Revision of Manuscript Number: IEEE-TPWRS-01391-2021, version 1 January 9, 2022
Journal: IEEE Transactions on Power Systems
Author: Abhishek Halder, Kenneth F. Caluya, Pegah Ojaghi, Xinbo Geng

Response to decision:

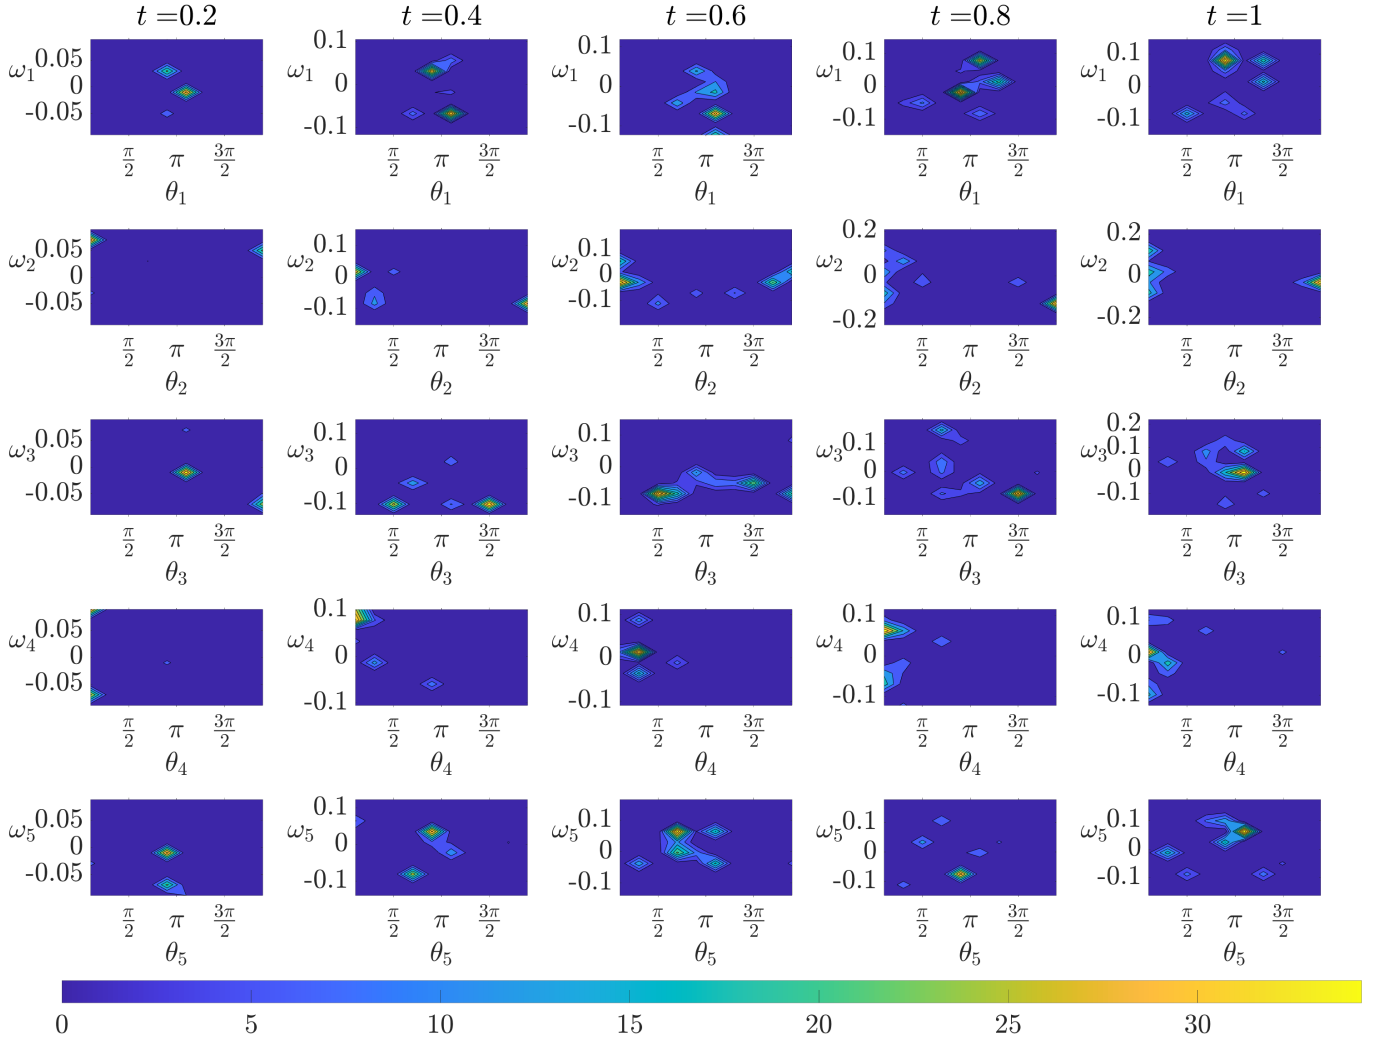
Figures 5 and 6 are unreadable.

Response: Thanks for this comment. In the previous version, the strict 10 page limit enforced small figure sizes. In the revised manuscript, Figures 5 and 6 are made larger. Also, the Fig. 6 in the revised manuscript shows the transient (θ_i, ω_i) bivariate marginals for all the five generators in Case II; the previous version showed the same only for the generator 4 (bus 6). We believe these changes have improved clarity.

Regarding the style of plots, we had considered plotting the bivariate marginals as planar contour plots (as in Fig. 1 in this rebuttal document) but decided against it because of the following two reasons.

First, in our opinion, this kind of plot is scientifically misleading as they hide the fact that these bivariate marginal PDFs are not really supported on the plane, or the subsets thereof, but instead have cylindrical supports. Our message that the proposed method explicitly accounts this manifold geometry in the computation, would be missed had we chosen to make the plots as per populist cognitive bias on behalf of the readers. That the planar plots evoke a sense of familiarity cannot be a scientific argument in favor of it.

Second, the planar contour marginal plots require additional mental efforts from the readers to correctly parse the statistical information conveyed. For instance, consider the fourth column, second row subplot in Fig. 1 in this rebuttal document. It is upon the reader to parse that the two high probability regions on the left and right of that subplot are actually referring to the same angular high probability region around $\theta_2 = 0$ rad, thanks to the periodic boundary condition on the angular variable. Our philosophy of technical communication is that the onus is on the authors, not on the readers, to clarify the scientific information as correctly as possible. And yes, we are aware that many papers in the power system literature make plots in the rectangular domain ignoring the manifold nature of the support, which in our experience, continue to add pain to the graduate students and beginning researchers trying to decipher the statistical meaning conveyed in those plots. We thus prefer to make plots that depict the variables as they are.
